BUSINESS CREATION UNIT AUDIO

SERVICE NEWSLETTER

06.01 TYPENUMBER(S): Philips CD-recorders and copy-protected Audio CDs

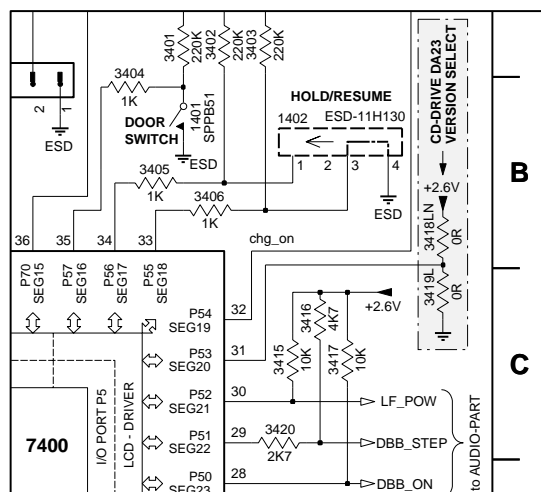
Attention when replacing DA23LPH by DA23LNPH !

The new drive requires different software parameters and will not work properly without the following hardware modification:

1. Remove pull-down resistor 3419L
2. Add pull-up resistor 3418LN

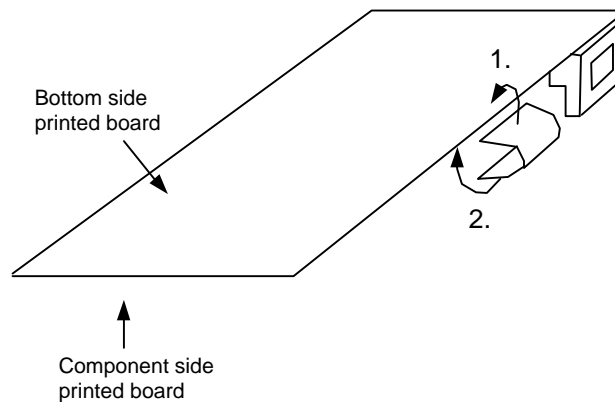
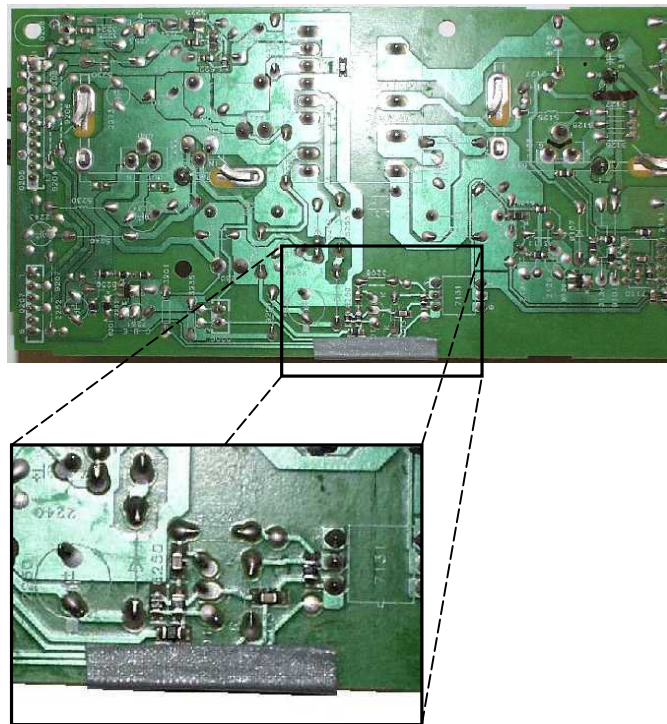
SYMPTOM : **IRIS CODE 2 1 1 0**

- a) Set switches off when the mains cord is moved
- b) No function
- c) Set switches off intermittently

CURE : Add a 100µF capacitor (4822 124 41584) on position 2213 of the Power Supply Unit "PSU CDR3 ECO".
For reference see Service Information A00-254.

Portion of Circuit on page 8-7

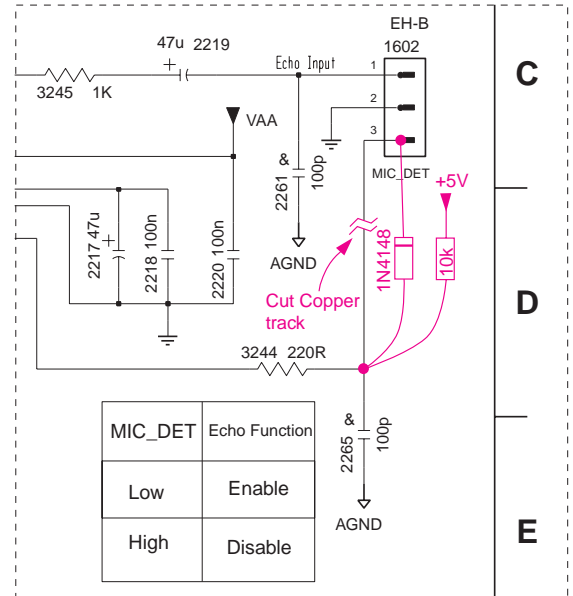
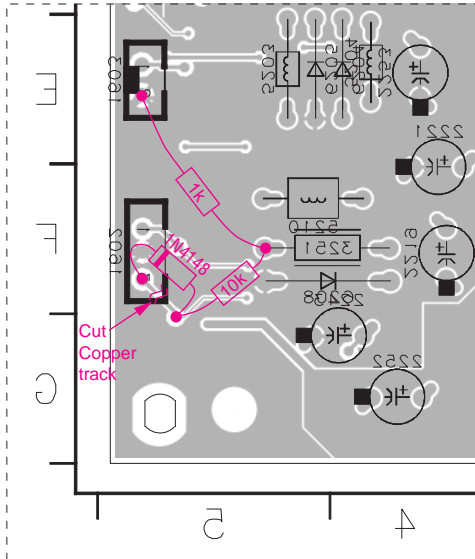
- SYMPTOM** : **IRIS CODE 1 5 4 2**
No music, only noise is audible during MP3 playback.
- CURE** : Due to residual voltage, the MPEG board does not get a proper reset.
- The problem can be resolved by the following rework (see drawings on next page):
1. Cut a copper track
 2. Add a resistor 1k Ω (4822 050 21002) across +5V and ground
 3. Add a resistor 10k Ω (4822 050 21003)
 4. Add diode 1N4148 (4822 130 30621)

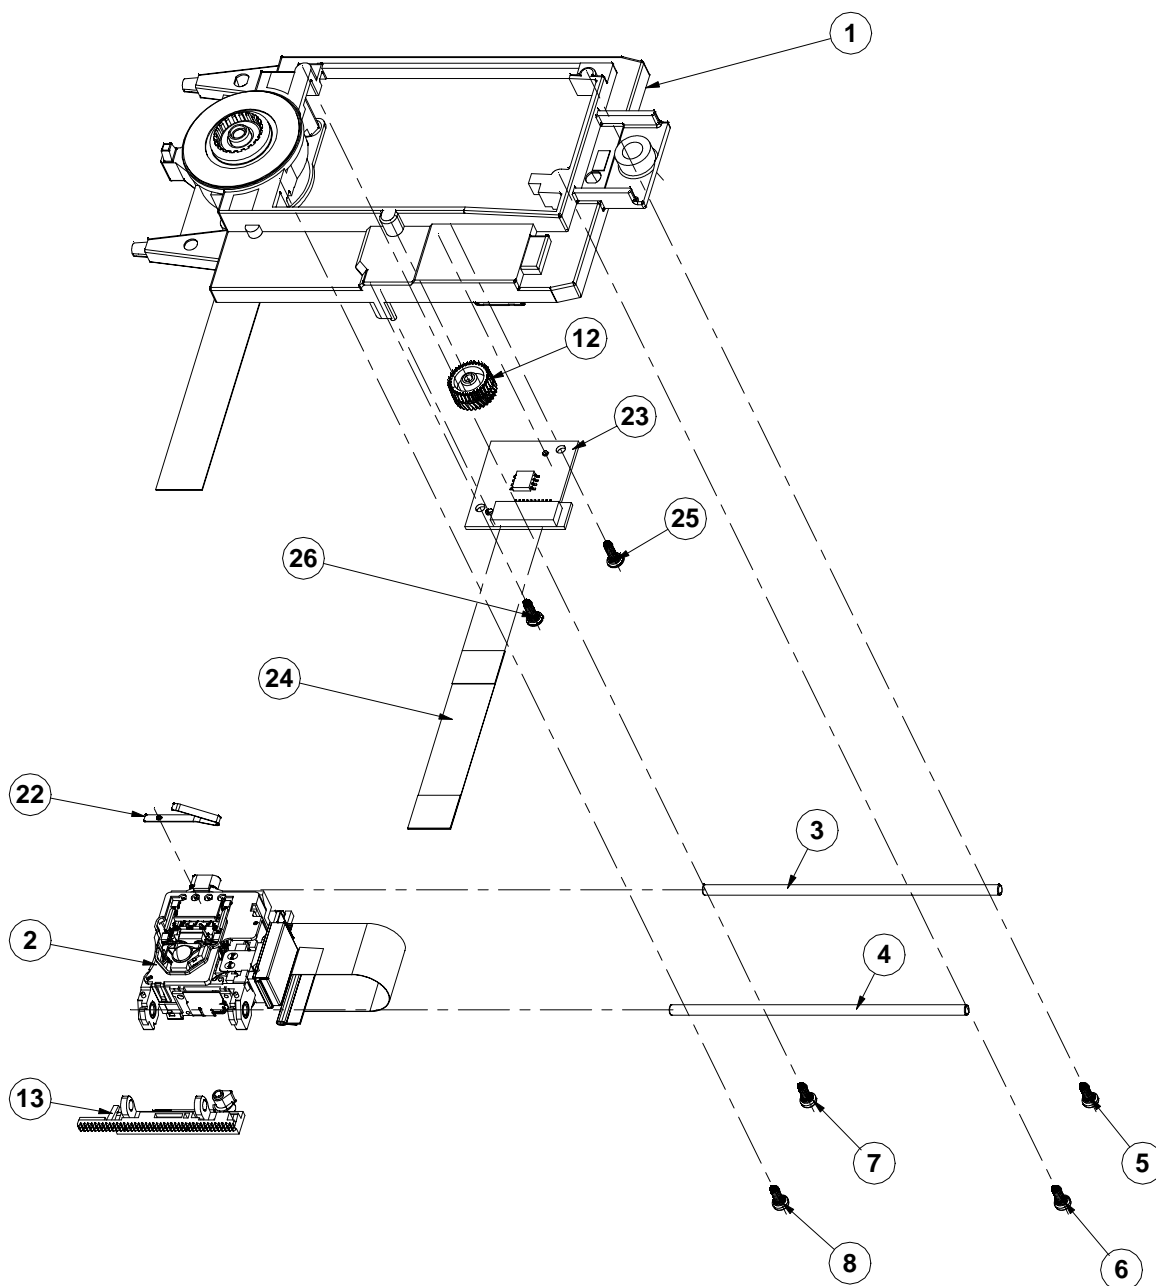
- 2.1. Mount the new axle ④ through new OPU and gear rack ⑬
- 2.2. Mount spring ②
- 2.3. Position the OPU under axle ③. Take care of spring ②.
- 2.4. Press the gear rack ⑬ in such a way that both rackteeth are in
line with each other. Interlock gear rack ⑬ with gear wheel ⑫.

The tension on the gear-rack will reduce the offset of the mechanical movement drastically.

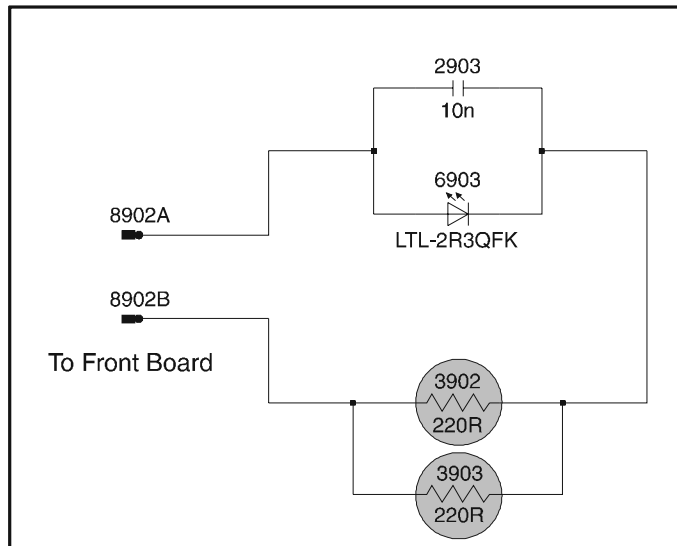
INFORMATION : Backlight board: In course of production, resistor 3903 has been added in parallel to resistor 3902 to prevent overheating. The value for both resistors is 220Ω, available with codenumber 4822 117 11503.

Portion of Combi Board, component side view

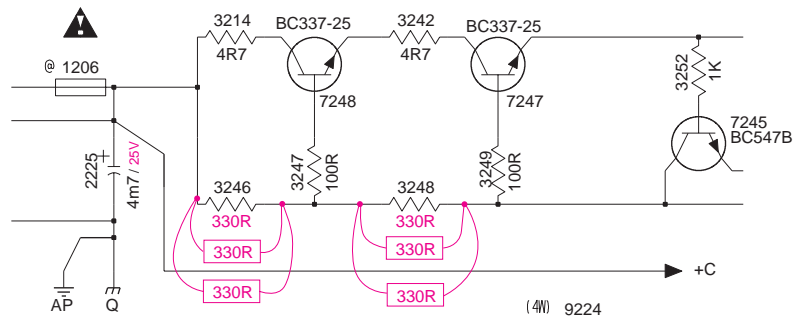
The set functions normally with the following observation on the Combi Board:

- Elcap 2225 4700µF / 16V becomes bloated.
- PC Board area below resistors 3246 and 3248 becomes blacken with overheating sign.

The problem is resolved by the following modification:

1. Replace Elcap 2225 with 4700µF / 25V (4822 124 12012).
2. Replace resistors 3246 and 3248 by 3 pieces of 330Ω 1/6W (4822 116 52219) each as follows:
 - replace 3246 and 3248 by 330Ω 1/6W
 - solder 4 resistors 330Ω 1/6W across 3246 and 3248 on the copper side as shown.

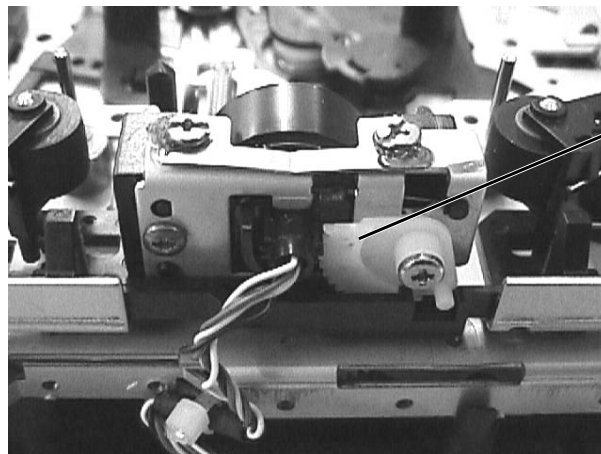
SYMPTOM : **IRIS CODE 1 1 6 D**
CD, Tape and Tuner not working, transistor 7233 (BD242BFP) blown.

CURE : Due to high inrush current at excessive mains supply values transistor 7233 becomes defective (C-E shorted). This causes a sudden increase of supply voltages +PA, +LED, +12A and +12M (jumping from +12 volts to +30 volts) killing other components along the way.

SOLUTION: Reduce value of Elcap 2245 from 1000µF 16V to 220µF 16V (4822 124 40196).
